**Re: Order on Consent ("CSO Order"), DEC Case #CO2-20110512-25
Modification to DEC Case #CO2-20000107-8, Appendix A
VIII. Newtown Creek CSO, M. Submit Approvable Drainage Basin
Specific LTCP for Newtown Creek**

Capital Project No. WP-169
Long Term Control Plan II

**Combined Sewer Overflow
Long Term Control Plan
Technical Memorandum
for
Newtown Creek**

April 2018

Figure 2-8. Annual Rainfall Data and Selection of the Typical Year

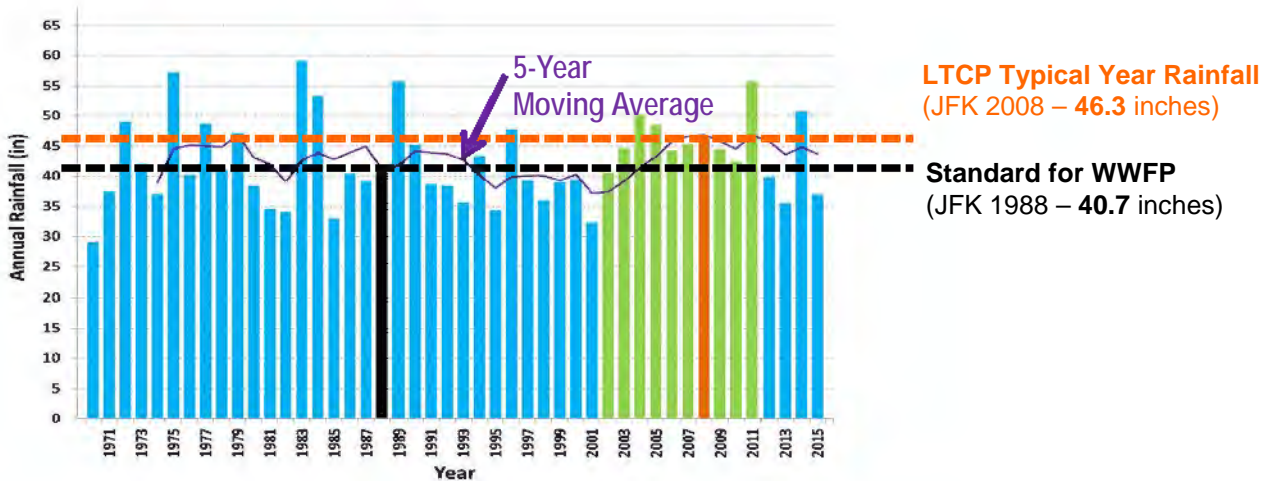
Figure 2-8 is deleted, and replaced in its entirety by the following Figure 2-8.

Figure 8-9a. Conceptual Underflow Baffle

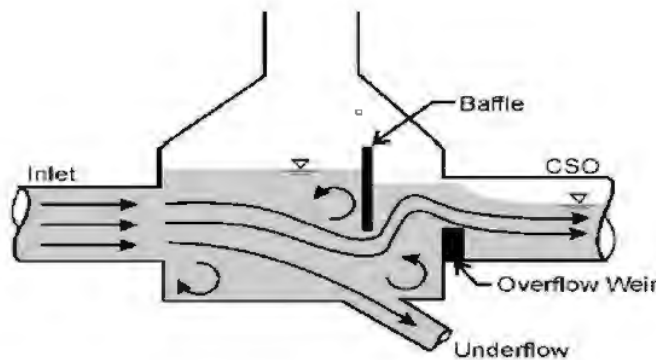
Figure 8-9a presents a schematic representation of a typical underflow baffle installation for floatables control at a CSO regulator. The intent of the underflow baffle is to retain floating material during the period of time that the hydraulic grade line in the regulator is above the elevation of the overflow weir, minimizing the discharge of floatables during CSO activations. Once the wet weather flows recede, the floatables held behind the baffle would be conveyed to the interceptor through the dry weather underflow connection. Key sizing criteria related to underflow baffle performance include:

- Offset between the bottom of the baffle and the overflow weir crest
- Flow velocity under the baffle during CSO activations
- Headloss created by the underflow baffle

Figure 8-9d. Section view of Regulator BBL-3B (Outfall BB-009)

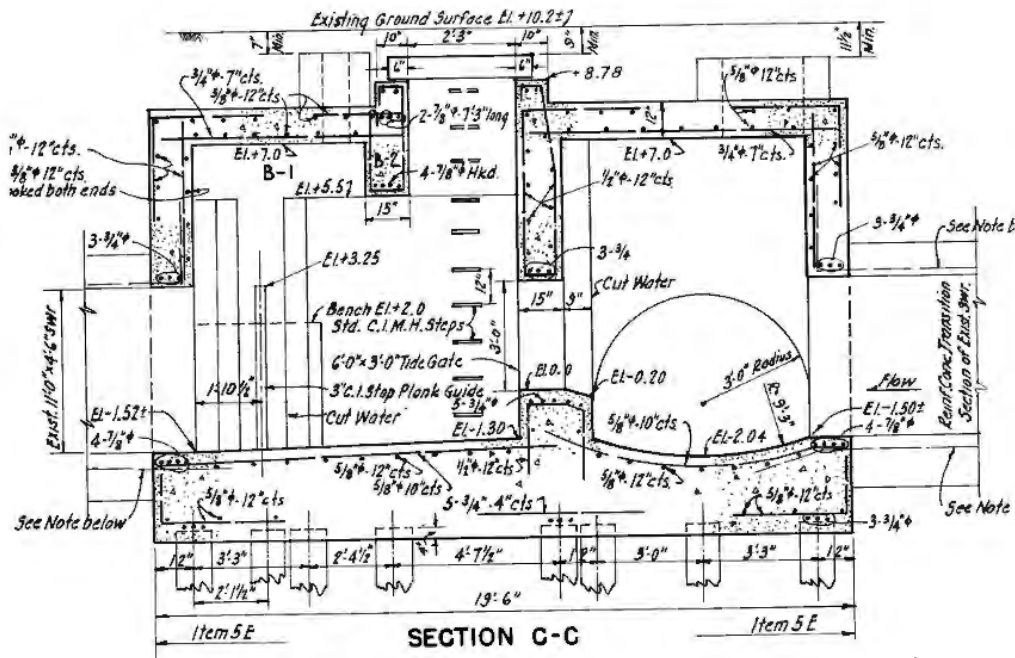
As indicated in Figure 8-9d, the depth between the weir crest and the invert elevation in the regulator upstream of the weir is only 2.04 feet. In order to achieve the 1.0 ft/sec criterion for the 90th percentile flow with the bottom of the baffle set 0.25 feet below the weir elevation, the weir crest would need to be raised by 0.34 feet. However, when this configuration was assessed with the 5-year, 2-hour storm, and the headloss through the regulator was predicted to increase by over 8 feet. Therefore, modifications to the regulator would be needed to offset the predicted increase in headloss associated with the underflow baffle. Through an iterative process, hydraulic neutrality in the 5-year, 2-hour storm was predicted to be achieved through a combination of lengthening the weir and baffle by 6.5 feet, increasing the height of the opening over the weir by 11 inches, and adding a third tide gate. Lengthening the weir and baffle by 6.5 feet would require expanding the existing regulator structure. Figures 8-9e to 8-9g present the proposed modifications. Figure 8-9h shows the approximate outlines of the existing and expanded regulator structure projected onto a Googlemaps Streetview image. A bending weir was not considered for this location due to the elevation of the tide relative to the weir crest elevation. The peak high tide in the typical year at this location is approximately elevation 1.5, which is approximately 1.5 feet above the existing weir crest elevation. The modifications to regulator BBL-3B are predicted to reduce the annual activation frequency at outfall BB-009 from 27 to 24, and would increase the annual CSO volume at outfall BB-009 by about 1 MG (due to the reduction in headloss at the outfall during bigger storms). However, the annual volume at the hydraulically-related outfall BB-026 would drop by about 1 MG, resulting in no net change in the total annual volume of CSO to Dutch Kills. No other outfalls in the BBL system would be affected by this project.

Figure 8-9k. Section view of Regulator BBL-8 (Outfall BB-013)

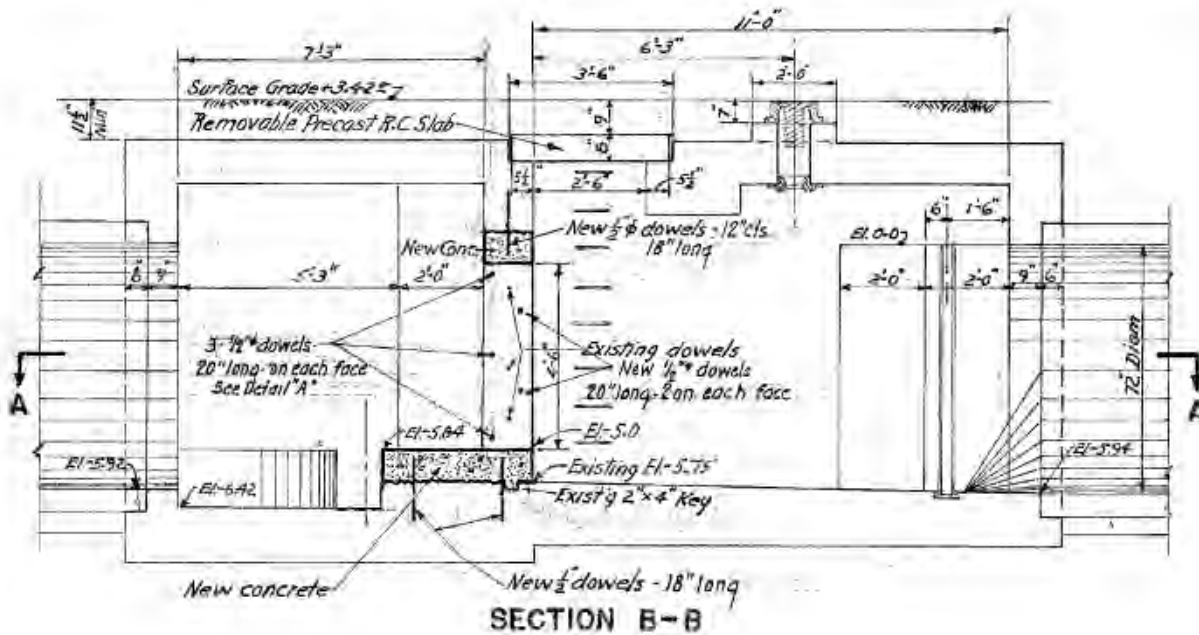
As indicated in Figure 8-9k, the depth between the weir crest and the invert elevation in the regulator upstream of the weir is only 1.42 feet. In order to achieve the 1.0 ft/sec criterion for the 90th percentile flow with the bottom of the baffle set 0.25 feet below the weir elevation, the weir crest would need to be raised by 0.8 feet. However, when this configuration was assessed with the 5-year, 2-hour storm, the headloss through the regulator was predicted to increase by just under 3 feet. Therefore, modifications to the regulator would be needed to offset the predicted increase in headloss associated with the underflow baffle. Through an iterative process, hydraulic neutrality in the 5-year, 2-hour storm was predicted to be achieved by expanding the regulator/tidegate structure to allow lengthening of the underflow baffle by 8.75 feet, and lengthening the overflow weir by 4.75 feet. A new overflow opening with a new tide gate would be needed to provide the additional 4.75 feet of weir length. These modifications would require the west side of the regulator/tidegate structure to be extended by 8.75 feet. Figures 8-9l to 8-9n present the required modifications. Figure 8-9o shows the approximate outlines of the existing and expanded regulator structure projected onto a Googlemaps Streetview image. A bending weir was not considered for this location due to the elevation of the tide relative to the weir crest elevation. The peak high tide in the typical year at this location is approximately elevation 1.5, which is approximately 6.5 feet above the existing weir crest elevation.

Figure 8-9n. Location plan for regulator modifications for underflow baffle at Regulator BBL-8 (Outfall BB-013)

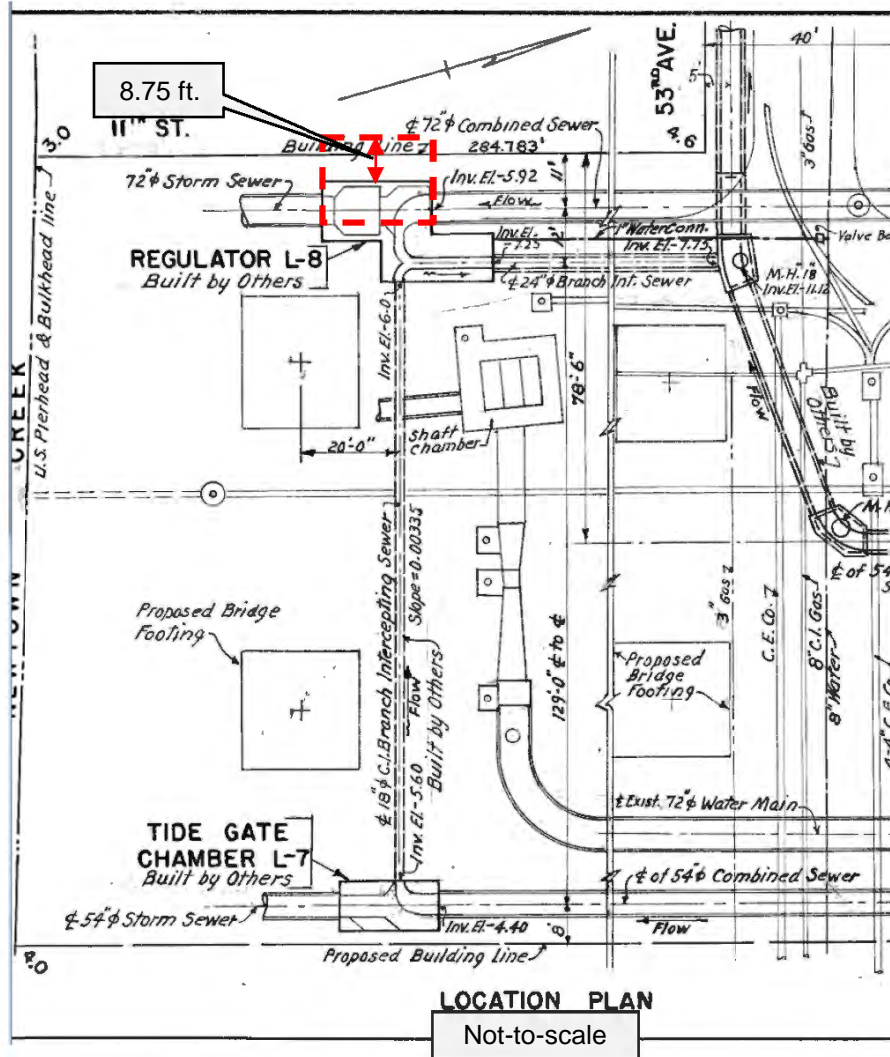
As indicated in Figure 8-9n, expanding the regulator by 8.75 feet would extend the structure past the building line along 11th Street. Based on a preliminary siting assessment, there does not appear to be sufficient space between the regulator structure and the building line along 11th Street to expand the regulator by 8.75 feet. Expansion on the other side of the structure would not be feasible due to the proximity of the bridge footing and the presence of the adjacent regulator structure. In conclusion, due to siting constraints, an underflow baffle would not be feasible at Regulator BBL-8.

Figure 8-9r. Section View of Regulator NCQ-2 (Outfall NC-029)

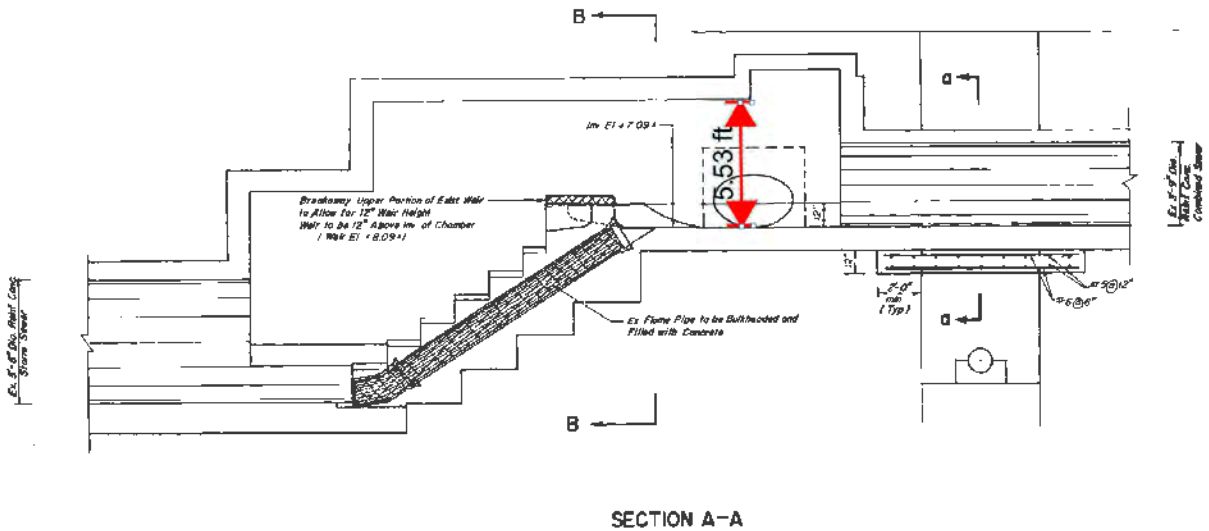
As indicated in Figure 8-9r, the depth between the weir crest and the invert elevation in the regulator upstream of the weir is only 1.0 foot. In order to achieve the 1.0 ft/sec criterion for the 90th percentile flow with the bottom of the baffle set 0.25 feet below the weir elevation, the weir crest would need to be raised by 0.7 feet. However, when this configuration was assessed with the 5-year, 2-hour storm, the headloss through the regulator was predicted to increase by over 10 feet. Therefore, modifications to the regulator would be needed to offset the predicted increase in headloss associated with the underflow baffle. Since the existing weir crest elevation is not influenced by the tide, a bending weir was considered as an option to reduce the needed lengthening of the weir. Through an iterative process, hydraulic neutrality in the 5-year, 2-hour storm was predicted to be achieved by expanding the regulator structure to allow lengthening of the underflow baffle by 7.5 feet, and providing a 1.25-foot high, 15.5-foot long bending weir. These modifications would require the west side of the regulator structure to be extended by 7.5 feet, with an additional 12 feet added for the counterweight chamber. Figures 8-9s to 8-9u present the proposed modifications. Figure 8-9v shows the approximate outlines of the existing and expanded regulator structure projected onto a Googlemaps Streetview image. The modifications to regulator NCQ-2 are predicted to reduce the annual activation frequency at outfall NC-029 from 40 to 37, and would decrease the annual CSO volume at outfall NC-029 by about 0.7 MG. No other outfalls in the Newtown Creek WWTP system would be affected by this project.

Newtown Creek Coordinated Schedule

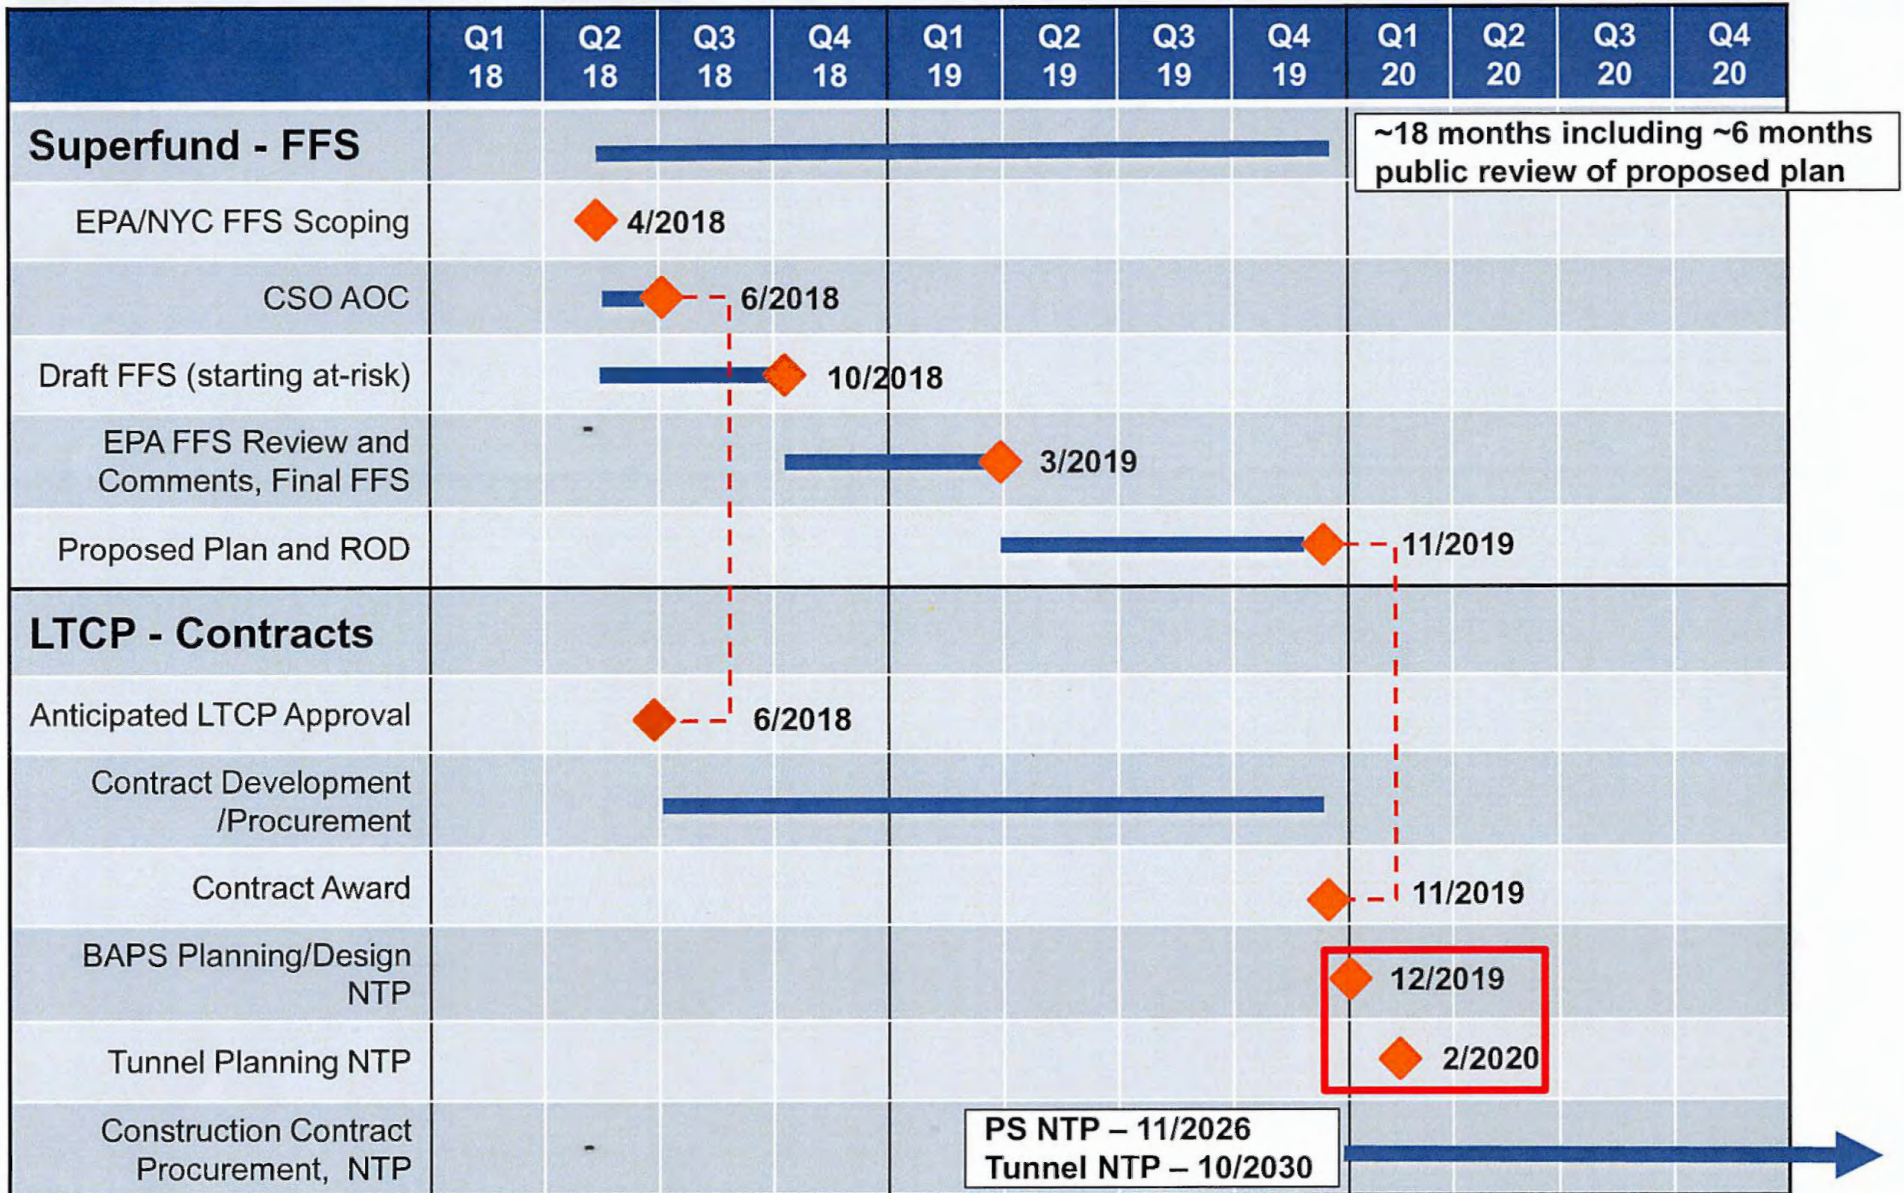
Accordingly, DEP has been coordinating with EPA and DEC on integrating the LTCP and Superfund processes. In January 2018, DEP proposed to EPA that DEP would conduct a Focused Feasibility Study (FFS) that would evaluate the effectiveness of the elements of the LTCP at addressing CERCLA contaminants in CSO discharges. DEP would utilize much of the data gathered and generated in developing the LTCP Recommend Plan, and would evaluate the data under the Superfund criteria set forth in the National Contingency Plan (NCP).

There is currently a ~5+ year gap between EPA Superfund ROD and LTCP project design initiation. FFS path forward (with some at-risk elements) addresses conflicts and minimizes risks.
